Service Bulletin

Bulletin No.: PI1013B

Subject: A/C Blows Warm Air Intermittently

Models: 2013 Chevrolet Spark

2754800

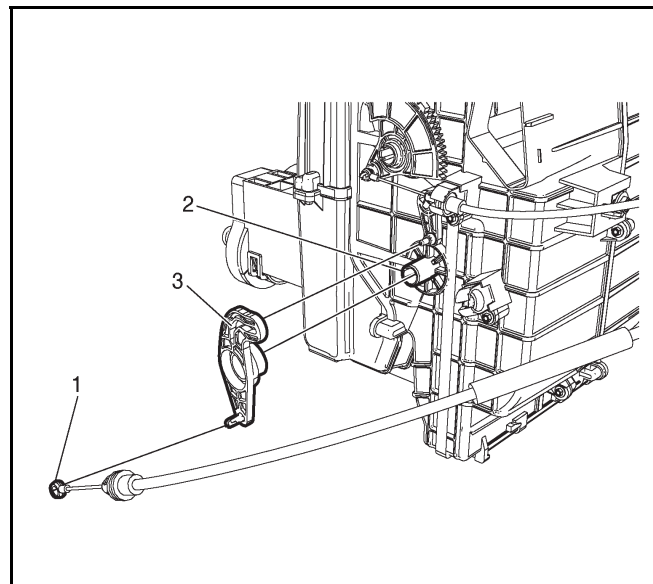
1. Replace the **WHITE** temperature cam link (3) shown in the illustration above with a black colored cam link. Refer to Temperature Valve Link Replacement in SI.

3516909

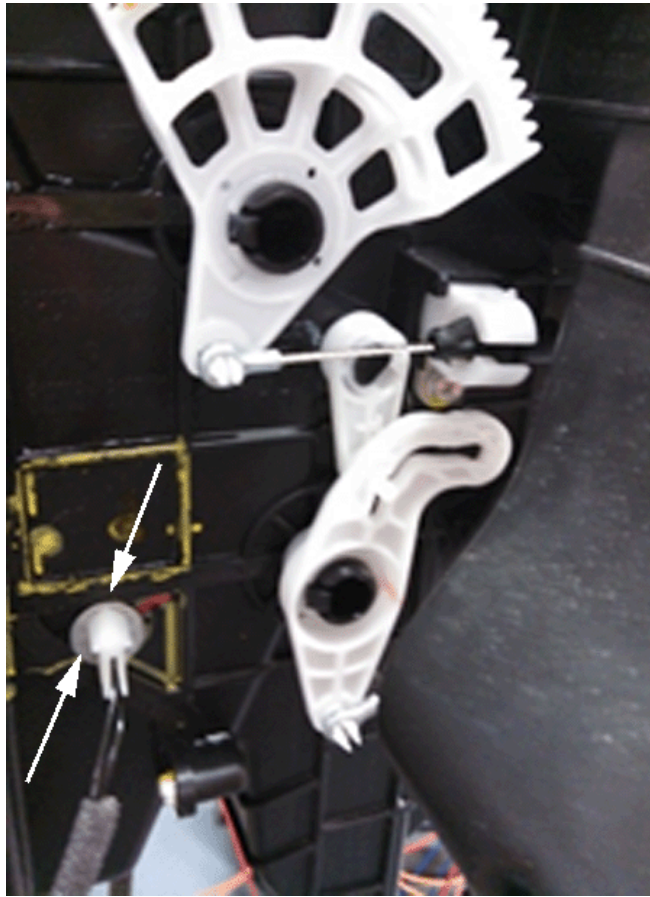
2. Remove the (EAT) sensor by turning the top of the sensor left and pull out.
3. Disconnect the wiring connector from the sensor.
4. Install the new sensor with the arrow at the 9 o'clock position, then turn right to the 12 o'clock position.
5. Connect the wiring connector.

Note: To determine if a new EAT sensor has already been installed, the new EAT sensor will be bent upwards and to the left of the base arrow. The new sensor is natural in color.
